1. 4 units from 20 units, screen went dark after 2 days or 2 weeks running, playing image pattern;

2. When the problem was happened, they pulled out all the statues register, listed as below:

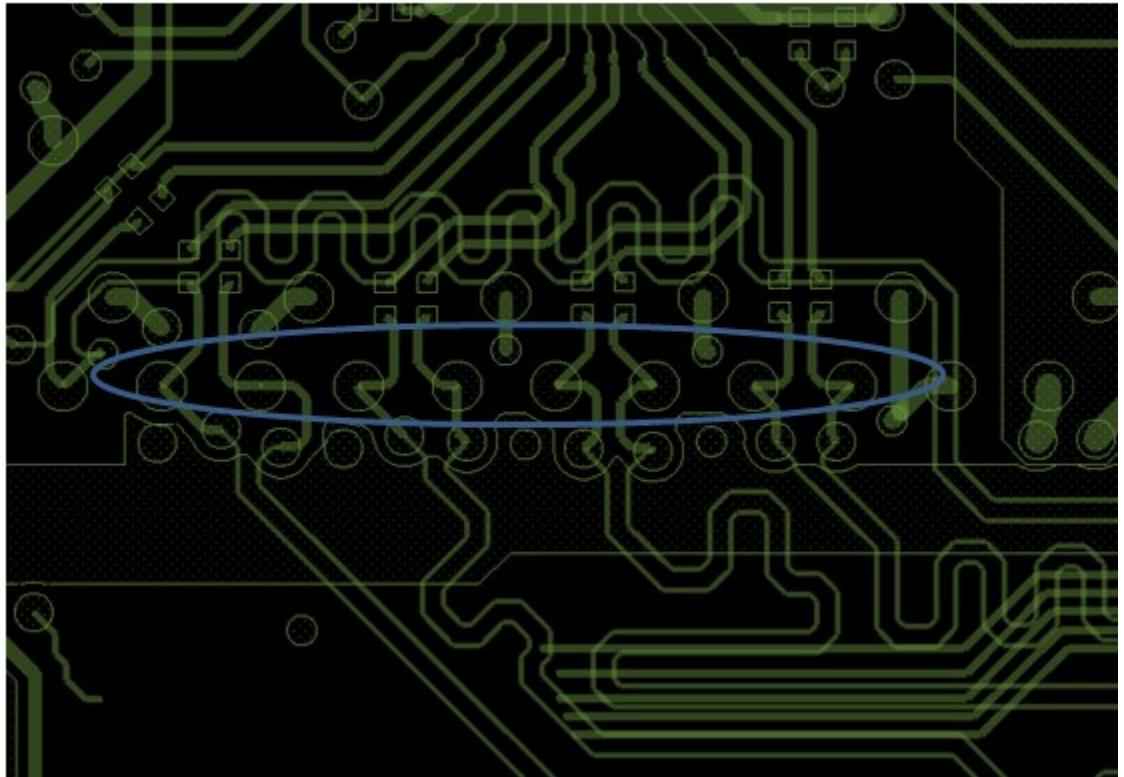
Two things I noticed when looking at their layout.

Why do they route the trace as circled below?

Please note our recommendation

The use of bends in differential traces should be kept to a minimum. When bends are used, the number of left and right bends should be as equal as possible and the angle of the bend should be $\geq 135^\circ$. This will minimize any length mismatch caused by the bends and therefore minimize the impact bends have on reflection and EMI.

Second thing I noticed is the inter-pair skew on the DSI interface. The DSI86 samples data on rising and falling edge of DSI clock. Any variation in length between CLK and DATA lanes will impact setup and hold requirement. My recommendation is to match lane length as close to each as possible. DSI_A data/clock should be within 5 mils of each other. DSI_B data/clock should be within 5 mils of each other.

Customer needs to understand the inter-pair skew from DSI source to DSI 86 input. For a 4k2k 60MHz 18bpp, the DSI clock will be around 700MHz. The entire inter-pair skew needs to be less than 66ps.
